RE: Lot 6 Block 6 Volcano Cliffs Unit 5 SAD 227 6205 Keyenta Pl. NW
Grading and Drainage Plan
Engineers Stamp Date 1/11/2022 (E10D114)
Pad Certification Date 10/27/2021

DRAINAGE AND TRANSPORTATION INFORMATION SHEET (REV 6/2018)

LOT 6 BLK8 U5 VC 6205 KEYENTA PLACE GRADING AND DRAINAGE PLAN

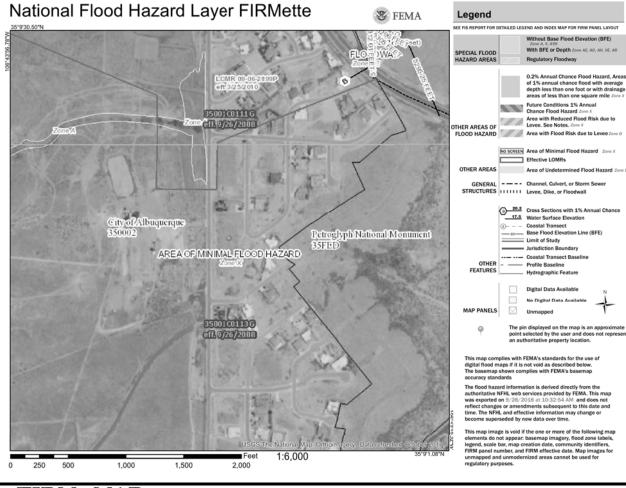
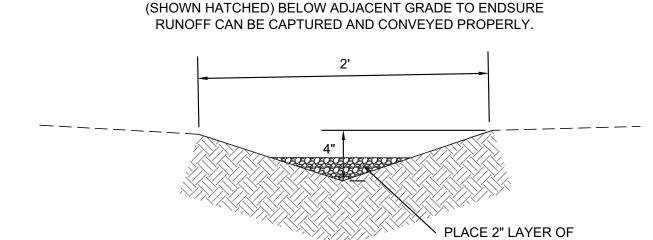
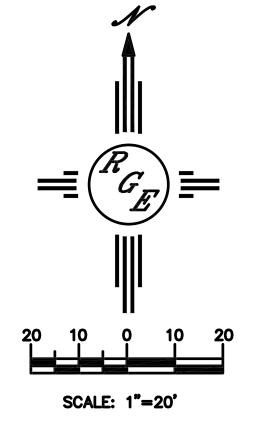
Based upon the information provided in your submittal received 3/25/2022, this plan is approved for Building Permit.

Reiterate to the Owner/Contractor that a separate permit for a garden/retaining wall must be obtained, with the approved G&D plan and Pad Certification. Also, let the owner/contractor know that if a pool is to be added in the future the G&D plan will need to be modified showing the location of the pool and the land treatment differences. Also advise the owner & Contractor that dirt is not allowed in the public right of way to climb the curb. Crusher fines or lumber is allowed. If dirt is used this will delay going forward with the construction of the home.

Prior to Certificate of Occupancy release, Engineer Certification per the DPM checklist of this plan will be required.
